21-COA-0030

2519 Cherokee Parkway

Cherokee Triangle Architectural Review Committee

Bradley Fister, Historic Preservation Specialist
April 07, 2021

**Low brick walls to be removed
from both sides of steps**

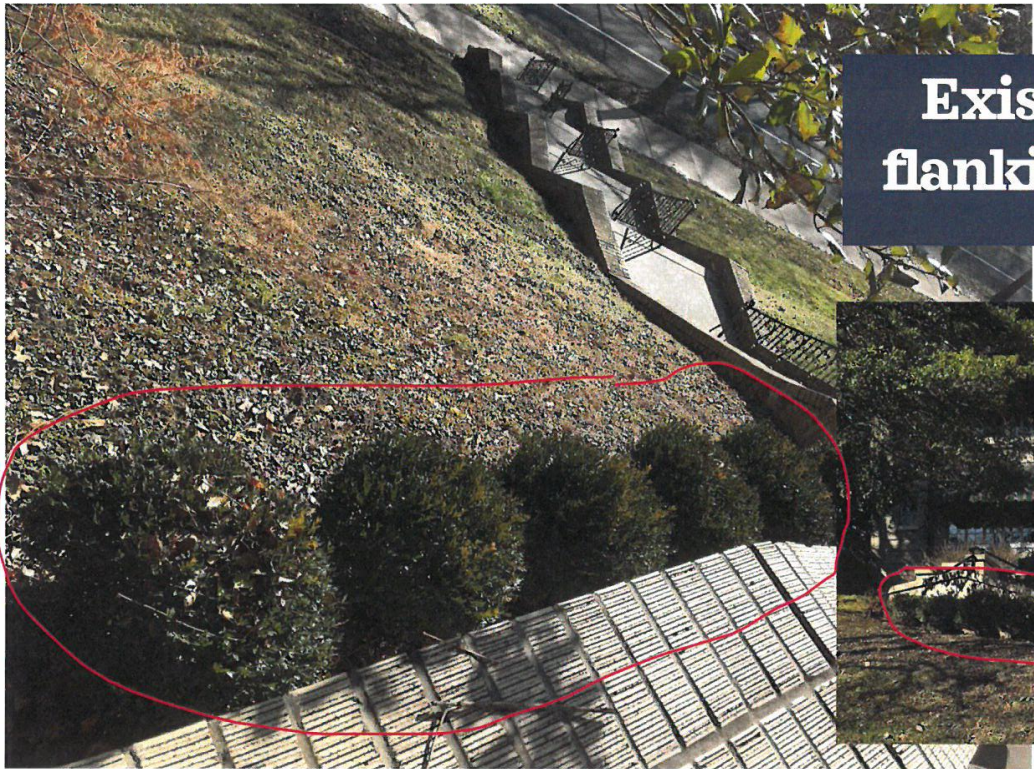
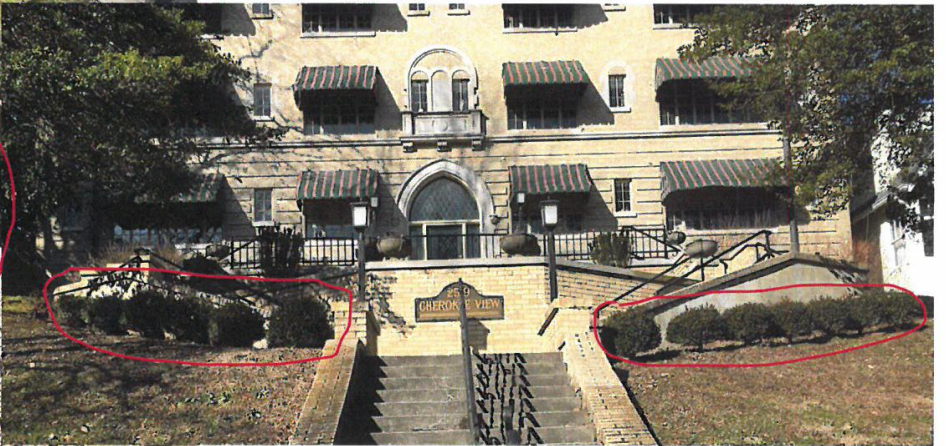
The existing buff brick side knee walls appear to be historic and original to the property. The proposal to remove the knee walls does conflict with Design Guidelines **ST1** and **ST5** which address site elements relationship with the building and states that original brick, stone, or concrete stairs should be retained. Though the sidewalls are in disrepair and unstable in places staff does not find them to be in such a condition that would warrant removal rather than repair. Staff recommends that the masonry knee wall be retained and repaired using appropriate masonry repair techniques.

1. The existing brick side walls on either side of stairs shall be repaired rather than removed.
2. The applicant shall reuse the existing brick and match the bond pattern and mortar mix as well as the joint profile. The masonry repair shall follow the guidance of the attached Masonry Design Guidelines.

Existing Railings on upper staircase to be matched on lower staircase

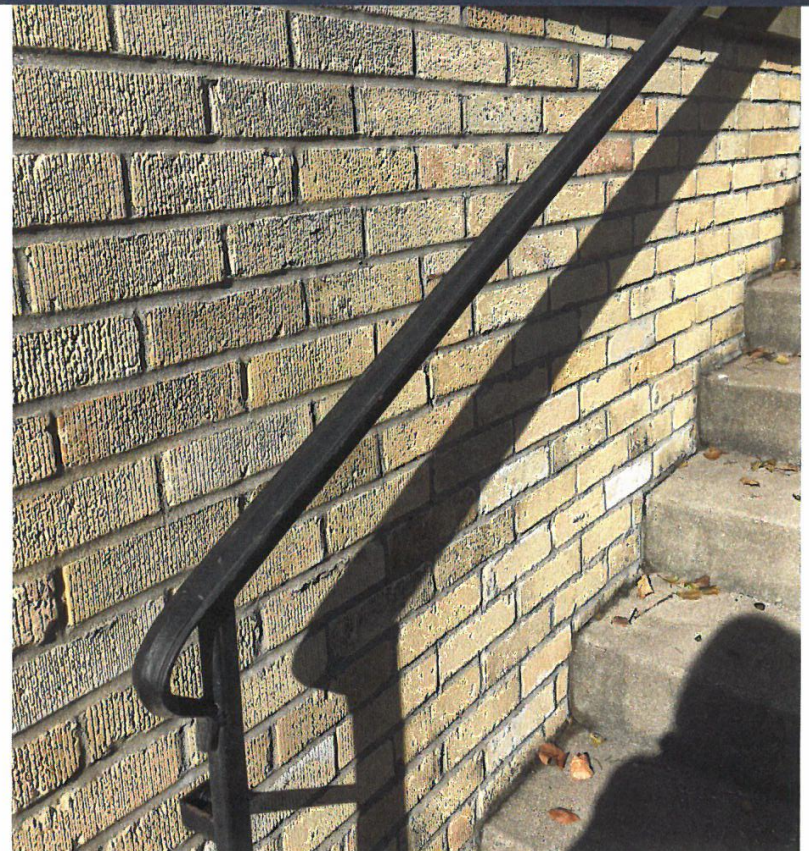
Existing Railings on lower staircase

The proposed work generally meets the **Site and Masonry** Design Guideline for the Cherokee Triangle Preservation District. The existing center stair handrail does not appear to be original to the property and staff supports the removal and replacement of the existing, for a cleaner and more streamlined design that matches the historic handrail system at the landing. Staff observed that the existing concrete stairs are in need of repair and resurfacing; and recommends this to be done with historic concrete mix and made to be uniform. Staff acknowledges the reason behind the proposal for a 6'x 6' walk to connect the sidewalk to the curb to prevent mud and soil erosion from the grass being trampled.

3. The applicant shall remove and replace the existing center stair handrail with one that matches the handrail that runs from the landing upward.
4. The applicant shall use historic concrete mix to repair the stairs, as well as to pour the 6' X 6' concrete walk to connect the sidewalk and the curb.
5. If the design or materials change, the applicant and/or their representative shall contact staff for review and approval prior to installation.
